REQUEST

Current Zoning: R-3 (single family residential)
Proposed Zoning: R-12MF(CD) (multi-family residential, conditional)

Approximately 30.73 acres located on the north side of South Tryon Street, south of Erwin Road, east of Choate Circle.

PLANNING STAFF REVIEW

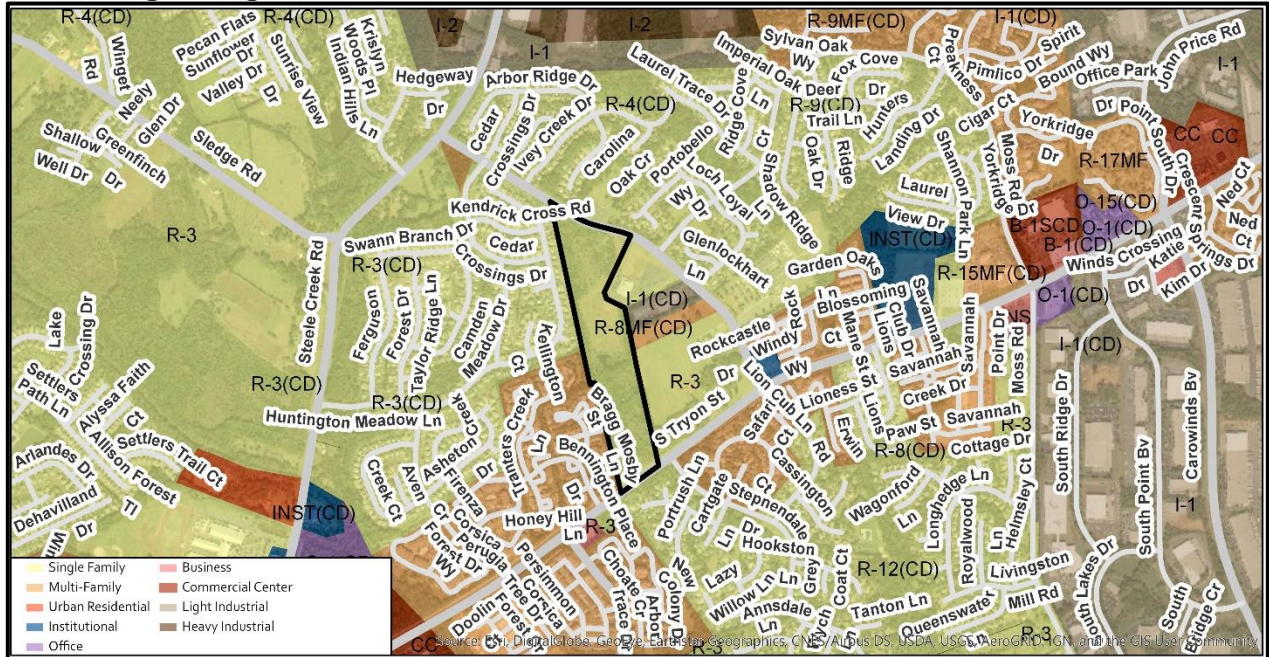
1. ~~Reduce density of proposal to better conform to the recommendations of the area plan.~~ Addressed.
2. ~~Consider reducing building masses of buildings 6, 7, & 8 to better transition to adjacent single family uses.~~ Addressed.
3. ~~Increase fence height from 5 feet to 6 feet along adjacent single family property lines, and clarify fence type to ensure it provides adequate screening.~~ Addressed.

4. ~~Under Site Data remove "Min. Building Separation: 10' Per Ordinance" from the site plan.~~ Addressed.
5. ~~Label setbacks along Erwin Road and Public Road A.~~ Addressed.
6. ~~Confirm if the area adjacent to proposed Building 3 is a dumpster enclosure/refuse area. If so, label on the site plan.~~ Addressed.
7. ~~Remove Monument Sign label and proposed location from the site plan.~~ Rescinded.
8. ~~Petitioner proposes a 50-foot Class C buffer along the western property line. Open Space and Amenities Note VII.3 proposes a "minimum 37.5-foot Class C buffer" in this location. Petitioner should clarify intent to have ability to reduce buffer by 25% with wall or fence per ordinance and modify labelling and development note to reflect consistency.~~ Addressed.
